CITY OF CONWAY, ARKANSAS HISTORIC DISTRICT COMMISSION

HISTORIC DISTRICT COMMISSION

320 Conway Blvd-Addition

719 Monroe St-Addition

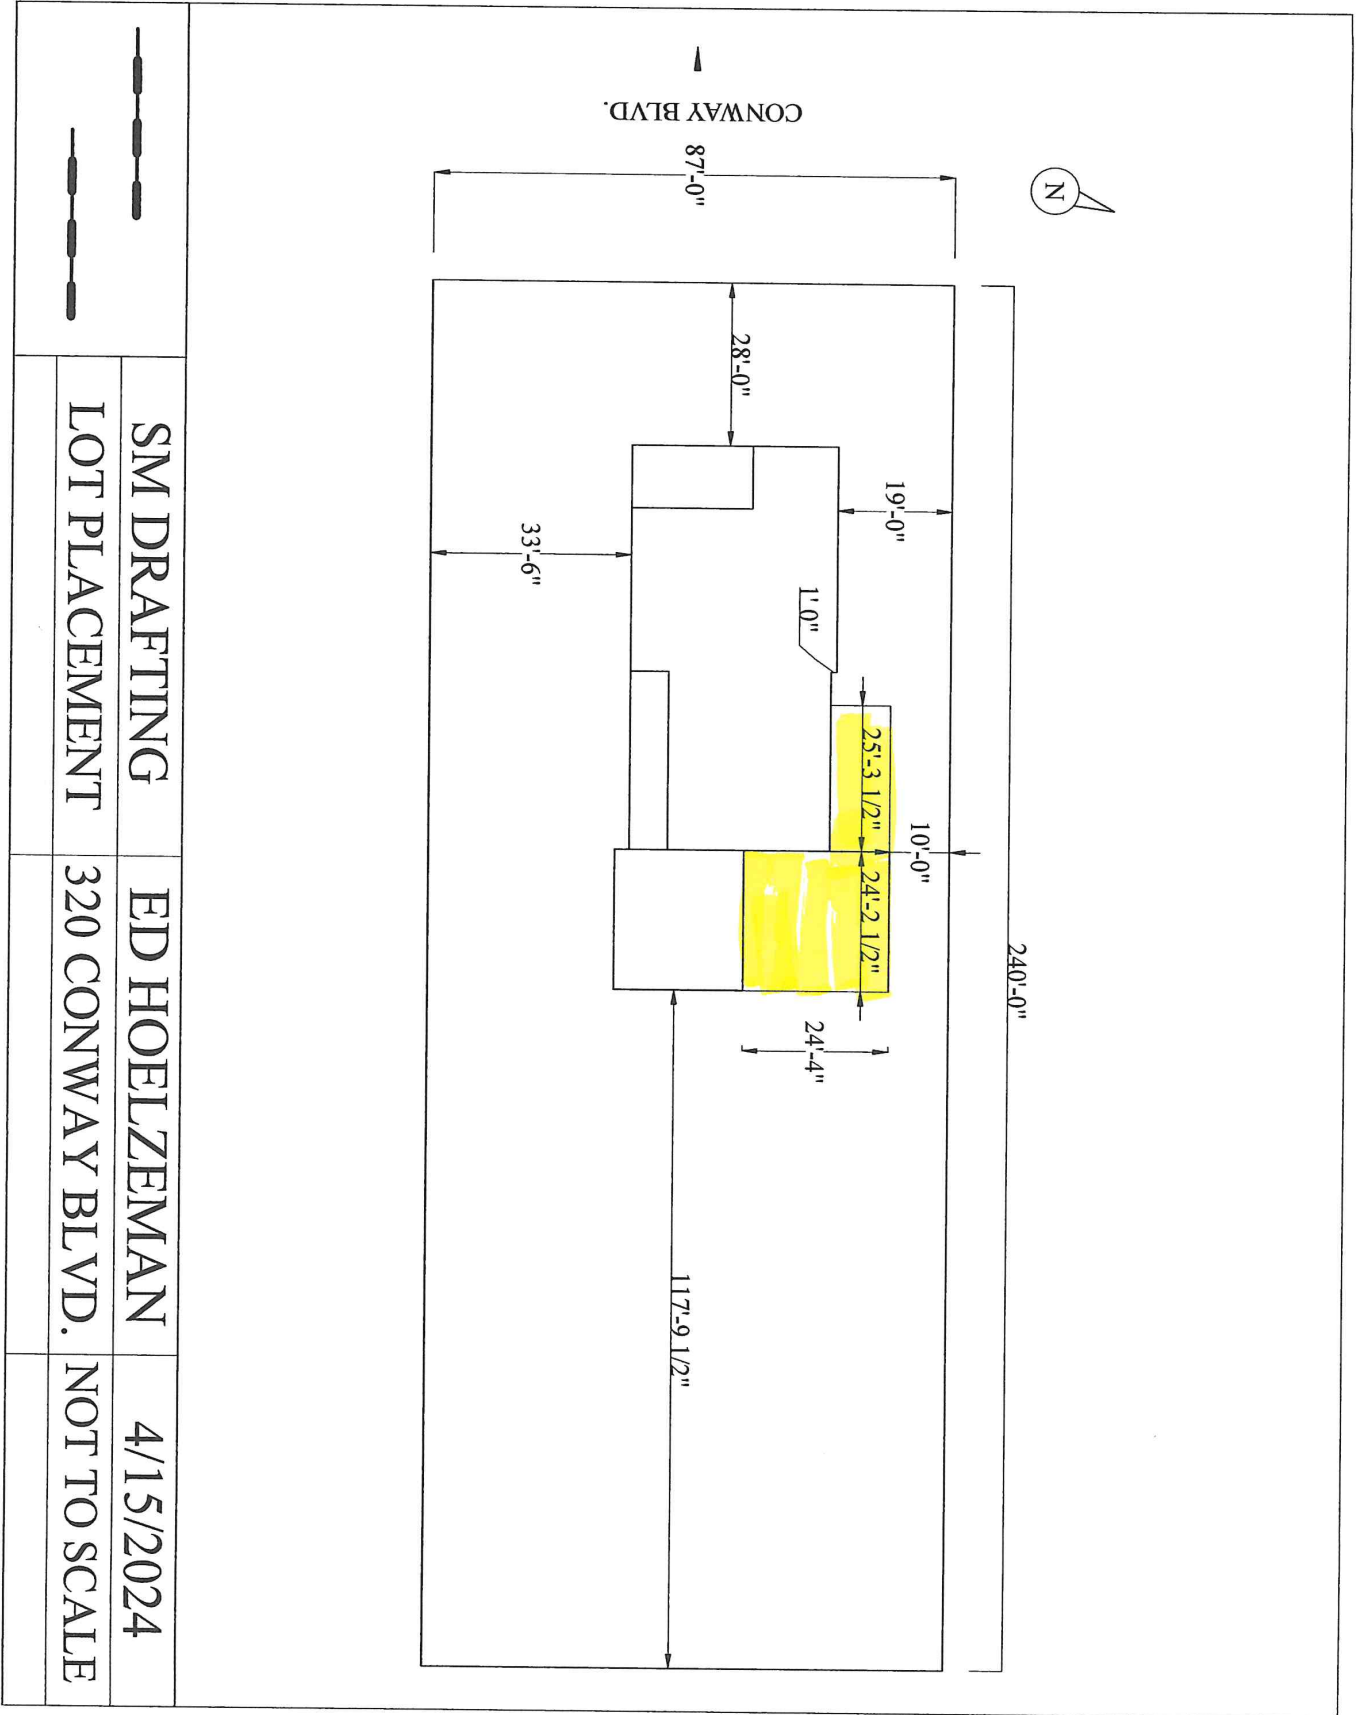
The addition has no impact on the front façade. It adds windows to the north elevation. The south elevation is enhanced by the addition of doors and the east elevation (facing the rear) is changed by the replacement of French Doors with sliding doors, but the change has a minimal impact on the overall rhythm of the design.

No porches are proposed. The proposed windows should feature wide trim and one-over-one design is encouraged. If muntin bars are proposed, they must be true divided lights. Fake muntin bars are prohibited.

The applicant is proposing vinyl siding to match addition. Normally, vinyl siding would be strongly discouraged but as the existing structure is already clad in vinyl, it is supportable.

No shutters are being proposed which is desirable. The applicant is proposing a gable roof with asphalt shingles. This is compatible with surrounding homes.

No HVAC equipment is shown on the site plan but is referenced in project description. It will need to be screened from view.

3. Windows shall be at least one-over-one (not fixed windows). If muntin bars are used, they must be true divided lights.
4. If the sidewalk is damaged during construction, it will need to be repaired.

5. Vinyl siding to match existing is permissible.
6. Lighting shall be downward and inward toward the property.
7. HVAC equipment shall be screened from public view.

NORTH
SITE PLAN
1"=10'

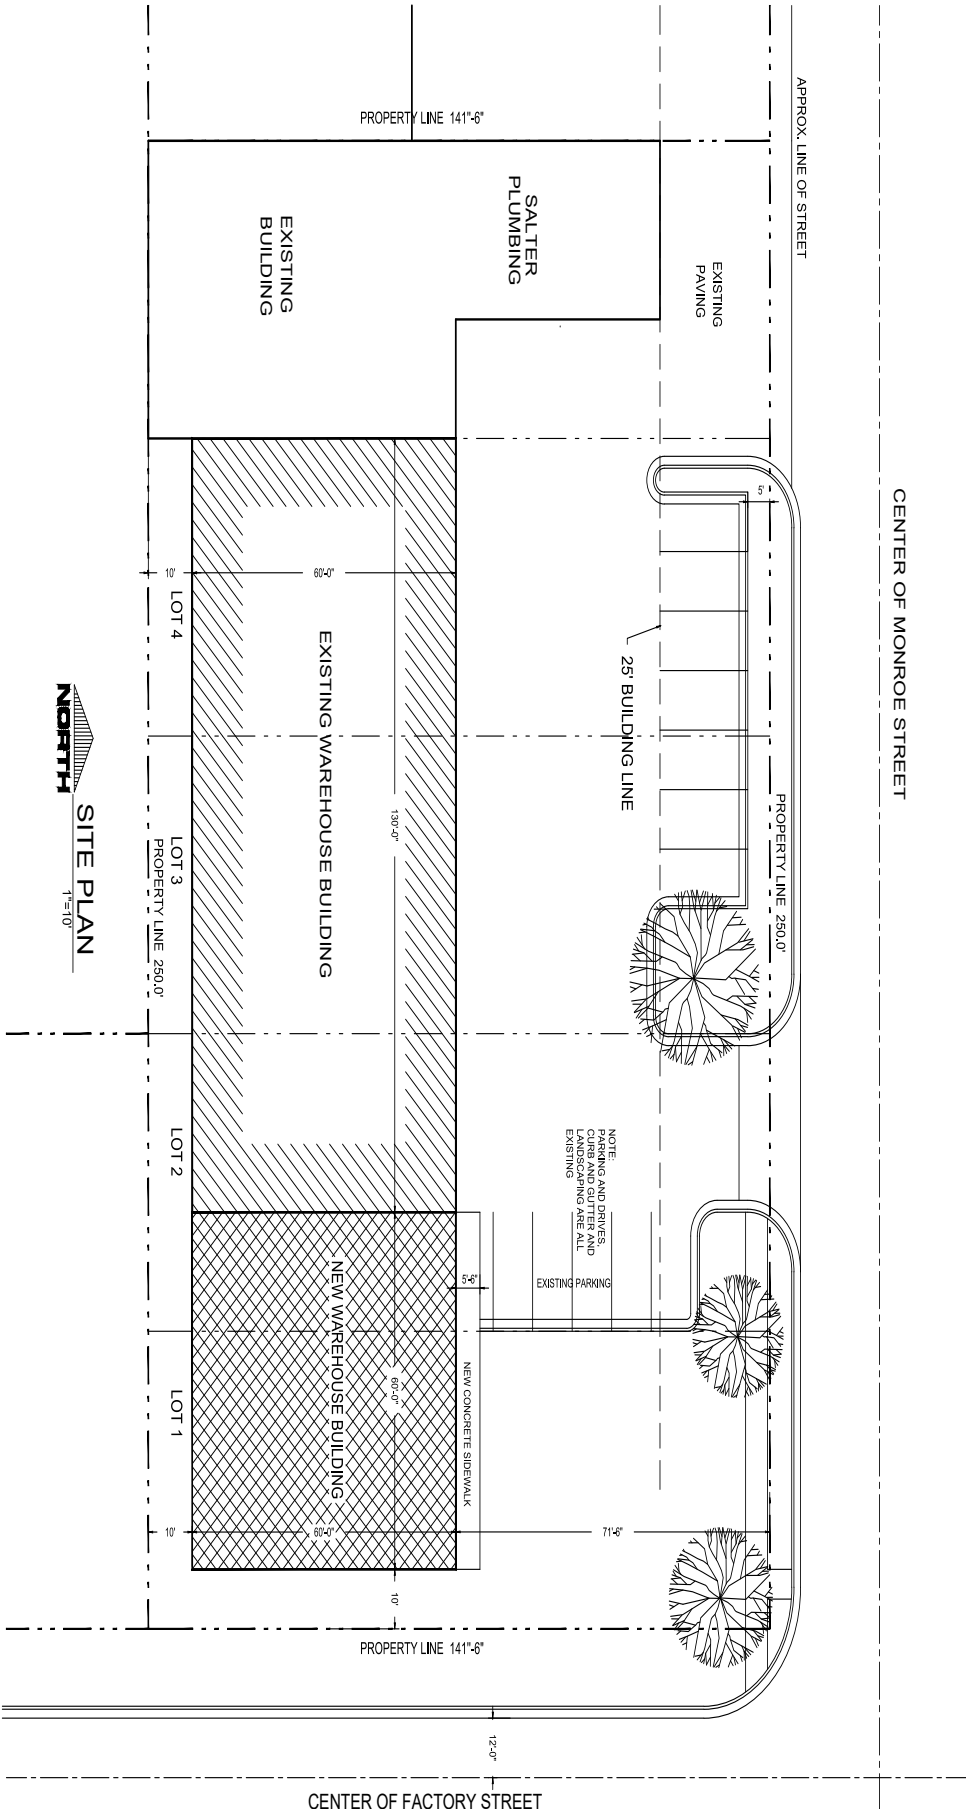
The proposed addition is 71' from the front property line as measured from the right-of-way. This matches the setback of the existing building. The proposed side yard setback is 10' and the rear is also 10'.

Sidewalks. Sidewalks shall be constructed and/or repaired for all street frontages and shall be a minimum of five feet wide, unless the width differs historically. *There is an existing sidewalk on Monroe St in good condition on and one on Factory St that needs restoration.*

Trees. Canopy trees shall be planted within the public street frontage at ratio of one tree per thirty feet. This tree planting will typically occur in the green strip lying between the sidewalk and curb line of the street. *There are trees along Monroe St which meet this requirement. There is also a tree between the existing structure and Factory St. If this tree can be retained it is sufficient to meet the tree planting requirements. If removed, it must be replaced. Additional landscaping in the form of shrubs along the base of the addition facing Factory St will help soften its appearance.*

Building Materials. Building materials (other than glass) shall include brick, stone, concrete, architectural metals, stucco/plaster, and wood trim. *The applicant is proposing Panel sheeting to match the existing building. The elevation facing Factory St will include brick accents. Given the context of the existing development and the surrounding area, staff supports these materials.*

2. Trees shall be retained on site. Where they cannot be retained, they shall be replaced 1:1 with species from the OCDOD approved tree list.
3. A landscape strip with shrubs shall be planted along the base of the addition facing Factory St.

4. Prior to issuance of a Certificate of Completion, sidewalks shall be restored on Factory St. They may be restored to the existing width.
5. Lighting shall be inward, downward, and shrouded so as to stay within the bounds of the property.

6. Utility apparatus, such as HVAC equipment, shall be screened from public view.
7. Materials shall be as shown on elevations. If substitute materials are used they must conform to the regulations for the Urban zone of OCDOD.
